WEBSTER UNIVERSITY ISB	
PROJECT NAME	
8274 BIG BEND BLVD	
ADDRESS	
NUMBER	
WEBSTER UNIVERSITY	
OWNER	
CANNON DESIGN	
ARCHITECT / ENGINEER	
Joe Voypick	
SUBMITTED BY	
042000-019	
CONTRACTOR / CM SUBMITTAL NO.	CANNON DESIGN SUBMITTAL NO.
	042000
DRAWING / DETAIL REFERENCE	SPECIFICATION SECTION / PARAGRAPH
Leonard Masonry	
MANUFACTURER / SUPPLIER	ITEM / PRODUCT ID
REQUIRED DATE	PRIORITY
	CRITICAL

PROJECT: 15051-Webster University Interdisciplinary Science Building

RE: Special brick Shape Shop Drawing

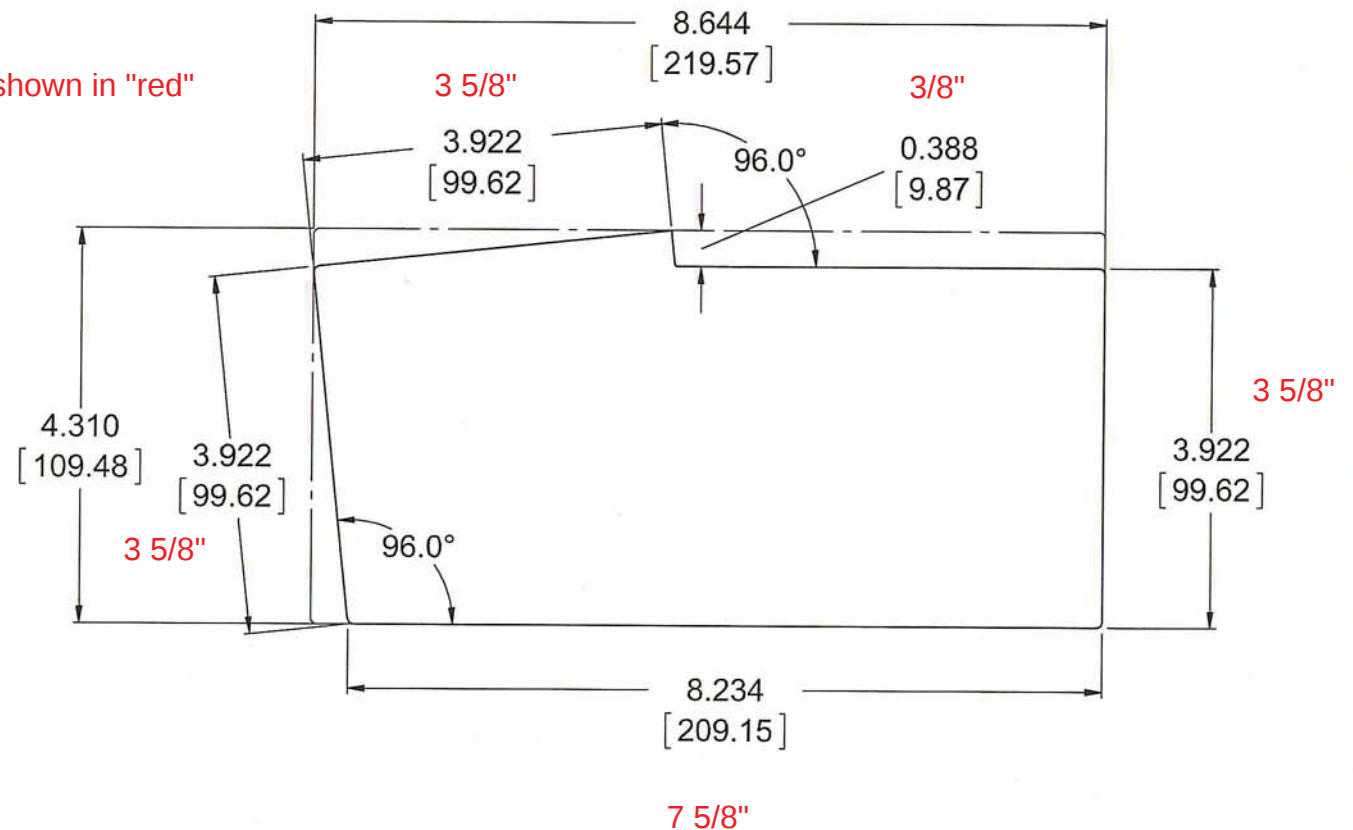
See dimensions listed in red for final dry brick dimensions.

Final dry brick dim shown in "red"

The attached drawing from Reymond International, shows dimensions the new housing will produce.
*Dimensions are for wet slugs, after drying and firing, the dimensions will match the original details from Webster.
